Errata Sheet

FirstNet Nationwide Public Safety Broadband Network

Final Programmatic Environmental Impact Statement for the Non-Contiguous United States Region

May 2017

Figure 1: FirstNet’s Notional Deployment Approach

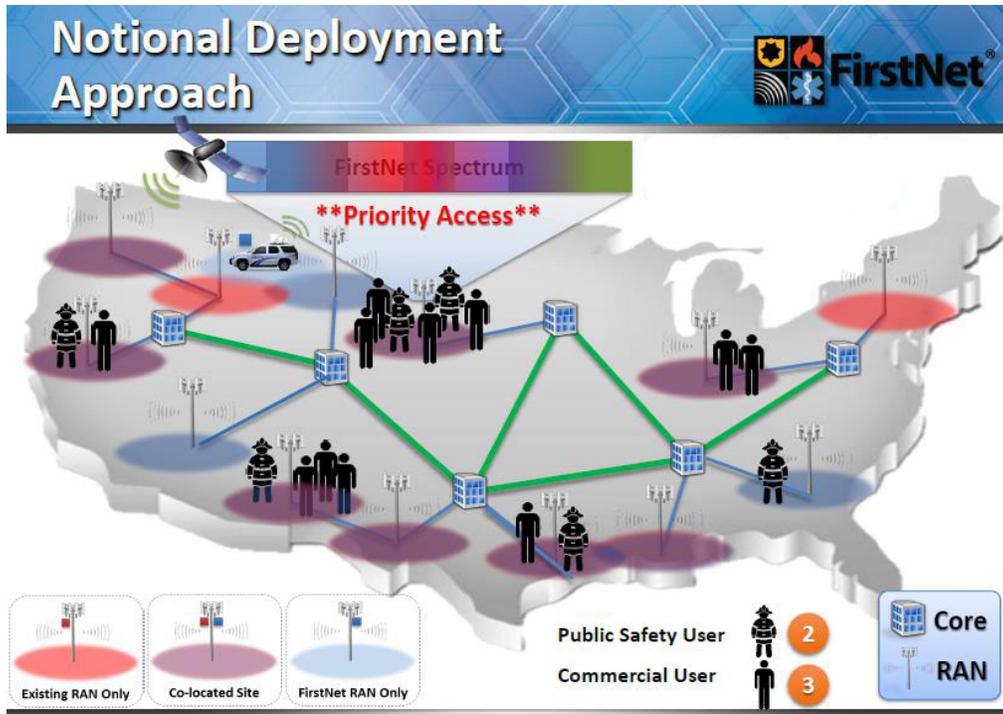
<p>Where the PEIS describes specific impacts from the different proposed projects (wired projects vs wireless projects), I would recommend cross walking these potential impacts to the diagrams or the same text descriptions found in section 2.0. I found I had to go back and forth between the two sections to figure out which facilities the PEIS was referring to and how they related to the proposed ones in section 2.0.</p>	<p>A detailed description of the Proposed Action is provided in Section 2.1, which provides the basis for the impact determinations for the resources listed in each of the various Environmental Consequences sections. While your comment is noted, it is not practical to repeat descriptions of the project types in the many instances they are mentioned throughout the Environmental Consequences sections.</p>	<p>Section 2.1</p>
<p>Under wireless projects, the PEIS states that for new wireless communication towers, deployment activities are expected to be temporary and isolated, but this is not the case if the new communication towers (or existing ones) use guy wires.</p>	<p>In the context of the Final PEIS, the term <i>deployment</i> refers to the construction of infrastructure, or the process staging deployable technologies for use. The Final PEIS includes a number of BMPs and mitigation measures designed to avoid the use of guy wires on communication towers, or where not avoidable, to reduce their avian impacts by other measures. Impacts to birds are considered to be less than significant for deployment or construction of the Preferred Alternative and less than significant with BMPs and mitigation measures incorporated for operations.</p>	<p>All Environmental Consequences Wildlife sections (3.2.6.4; 4.2.6.4; 5.2.6.4; 6.2.6.4; 7.2.6.4; 8.2.6.4; 9.2.6.4)</p>

Figure 2: An Estimate of Avian Mortality at Communication Towers in the U.S. and Canada (Provided by the USFWS)

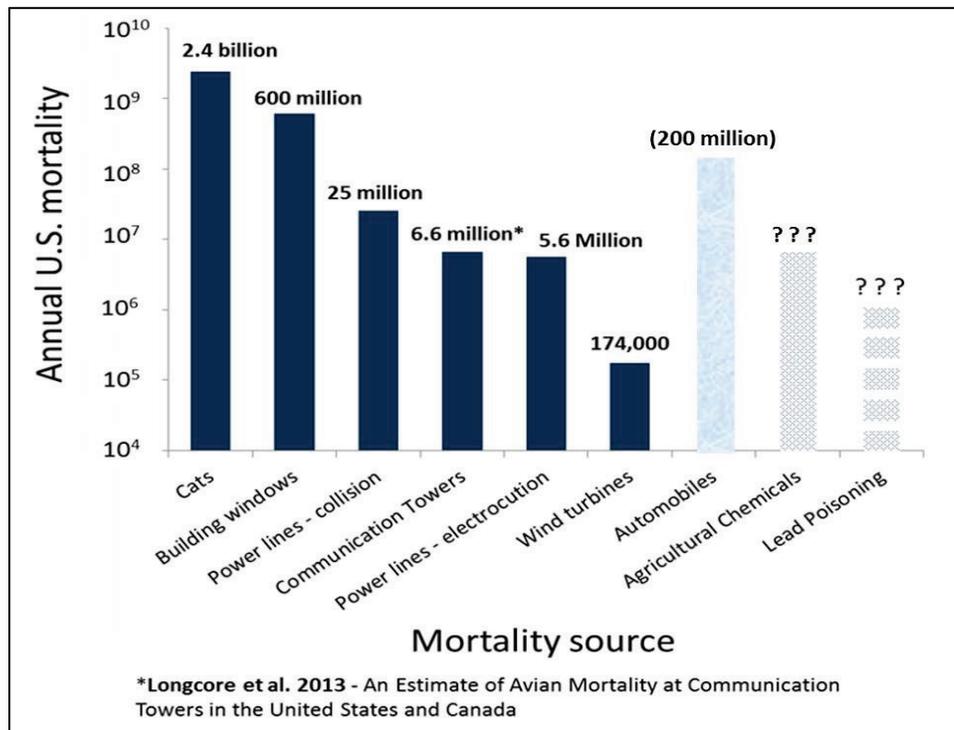
Comment Text	Response	Relevant Section(s) in Final PEIS
<i>Section 3.0: Wildlife and Vegetation</i>		
<p>Regarding migratory birds and direct mortality, reference to causes of mortality should include those listed in the updated communication tower guidance from FWS. See page 1 of that guidance for reasons for mortality, which are a little more specific than those listed in the PEIS.</p>	<p>The USFWS’ <i>Recommended Best Practices for Communication Tower Design, Siting, Construction, Operation, Maintenance, and Decommissioning (USFWS 2016)</i> elaborates on the specific causes of bird mortality as follows:</p> <p>“Given the height, structural engineering needs (i.e., guy wires), and obstruction lighting requirements, communication towers may cause direct and indirect bird mortality through:</p> <ol style="list-style-type: none"> 1. Collisions - Birds that are attracted to tower lights and aggregate in the lighting zone, circle the tower and collide with the tower, guy wires, other birds, or fall to the ground from exhaustion (Longcore et al. 2012b, Gauthreaux and Belser 2006, Erickson et al. 2005). 2. Construction, operation, and maintenance activities - Adults, eggs, or nestlings can experience direct mortality through: <ol style="list-style-type: none"> a. Trauma or death during vegetation removal; b. Trauma or death during tower maintenance; and c. Death of eggs or nestlings when actions or activities cause adults to abandon nests. 3. Significant loss of fat reserves in adults due to the energy expenditure of circling towers, leading to reduced survival during long migrations (Norris and Taylor 2006, Gehring and Walker 2012).” <p>In addition, the <i>Recommended Best Practices</i> provide updated avoidance and minimization measures. Those measures replace the USFWS guidelines on communications tower siting in Chapter 11.</p>	<p>All Environmental Consequences Wildlife sections (3.2.6.4; 4.2.6.4; 5.2.6.4; 6.2.6.4; 7.2.6.4; 8.2.6.4; 9.2.6.4) and Chapter 11 (Section 11.6.2)</p>
